Access Compliance Report

Public Rights-of-Way

(Pedestrian Signals)

Intersection ID: N/A	Main Street:	Cross Street: N/A	Location: N/A
ADA ID: F74CB322CAB0	Signal Type: One Push Button-Non APS	Overall Compliance: No	Severity Score: BTN 1: N/A BTN 2: N/A No BTN: N/A
Codes/Mitigation Info/Possible Solution		Field Measurements/Component Compliance

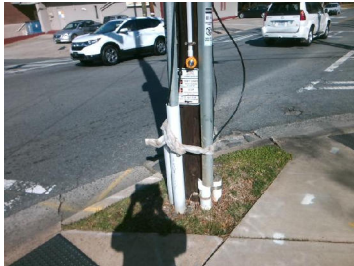
N/A	B 1 FWD Approach Width (in)	N/A	N/A	B 2 FWD Approach Width (in)	N/A
N/A	B 1 FWD Approach Obstruction?	Yes	N/A	B 2 FWD Approach Obstruction?	N/A
N/A	B 1 FWD Approach Obstruction Dist (in)	13.0	N/A	B 2 FWD Approach ObstructionDist (in)	N/A
N/A	B 1 PARA Approach?	Yes	N/A	B 2 PARA Approach?	N/A
N/A	B 1 PARA Approach Constrained?	No	N/A	B 2 PARA Approach Constrained?	N/A
No	B 1 PARA Approach Reach (in)	15.0	N/A	B 2 PARA Approach Reach (in)	N/A
N/A	B 1 PARA Approach Width (in)	N/A	N/A	B 2 PARA Approach Width (in)	N/A
N/A	B 1 PARA Approach Obstruction?	Yes	N/A	B 2 PARA Approach Obstruction?	N/A
N/A	B 1 PARA Approach Obstruction Dist (in)	15.0	N/A	B 2 PARA Approach ObstructionDist (in)	N/A
No	B 1 Clear Floor Space Slope (%)	2.1	N/A	B 2 Clear Floor Space Slope (%)	N/A
No	B 1 Clear Floor Space XSlope (%)	2.1	N/A	B 2 Clear Floor Space XSlope (%)	N/A
N/A	B 1 PAR Slope (%)	2.0	N/A	B 2 PAR Slope (%)	N/A
No	B 1 Height (in)	57.0	N/A	B 2 Height (in)	N/A

Possible Solutions: Adjust Signal Button Height. Provide Push Button Extension. Remove and Replace Clear Space.
